Technical Service Bulletin: TSB190170

Front Gear Cover Inspection to Prevent Front Gear Cover Cracking

- QSK23 CM500
- QSK23 CM2250 K109
- QSK23 CM2350 K127

Figure 1, Example Location of a Blind Tapped Hole on Front Gear Cover.

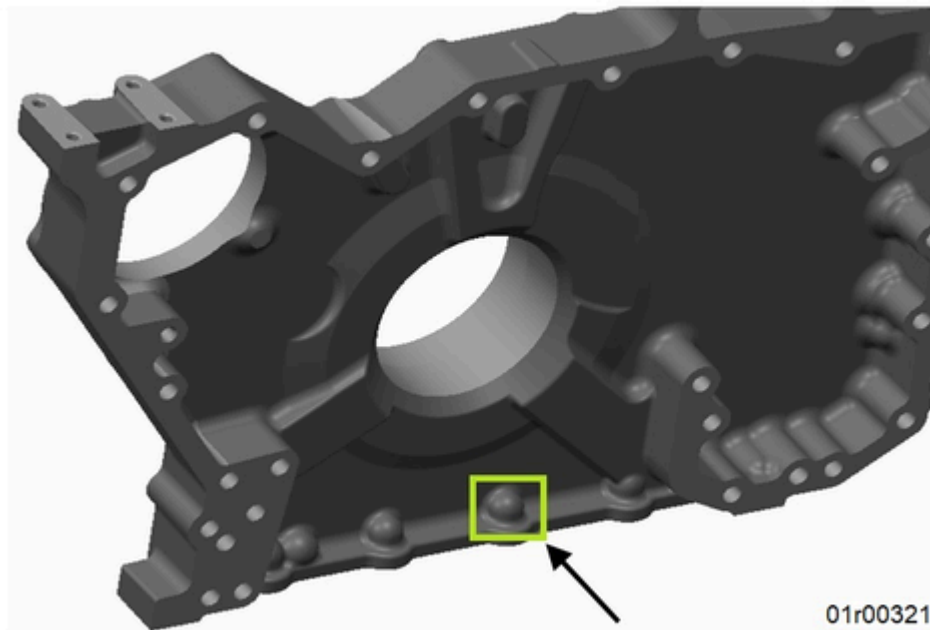
- Debris or sealant in blind tapped holes in front gear cover

- When removing the front gear cover, clean and remove debris and sealant from the blind tapped holes in the front gear cover.
- The presence of sealant in the blind tapped hole in the front gear cover leads to less capscrew thread engagement. The exerted pressure when the capscrew is torqued, can cause the front gear cover to crack.
